Cassidy Forsythe were asked to model the proposed bridges on the Norwich Northern Distributor Road in order to determine whether there was sufficient clearance between the proposed road design and the bridge.

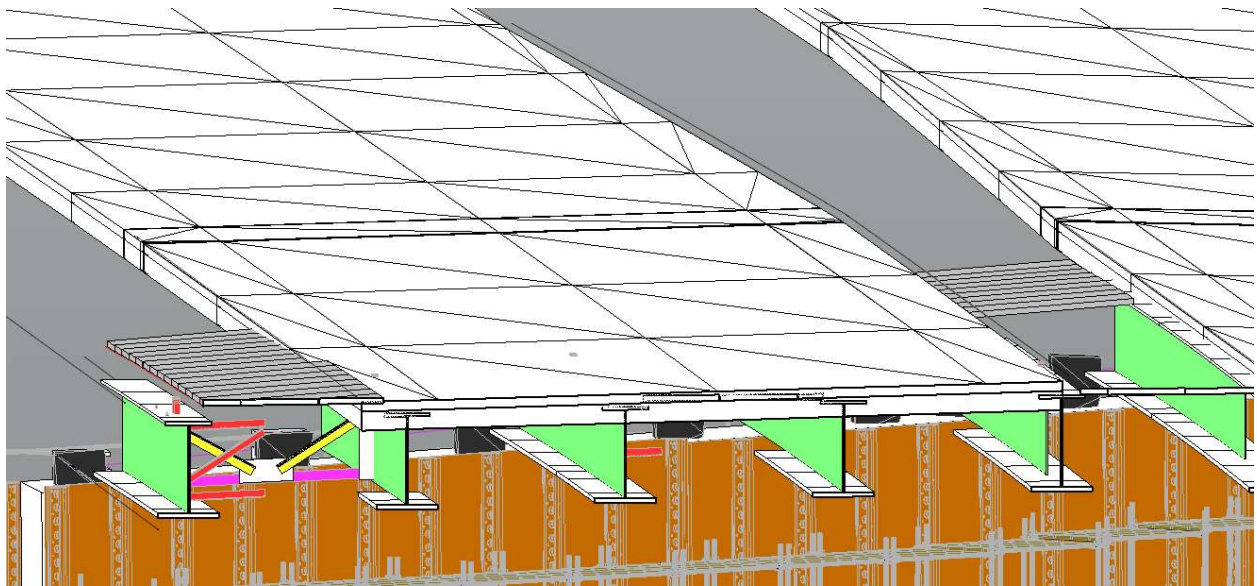
Once we had modelled the bridge and the road it became apparent that there wasn't enough level difference between the proposed road levels and the proposed beams to accommodate the road surfacing and the deck, as shown below

This problem was subsequently sent back to the road designers who had to raise the vertical alignment of the road to allow for the road pavement layers and the deck construction.
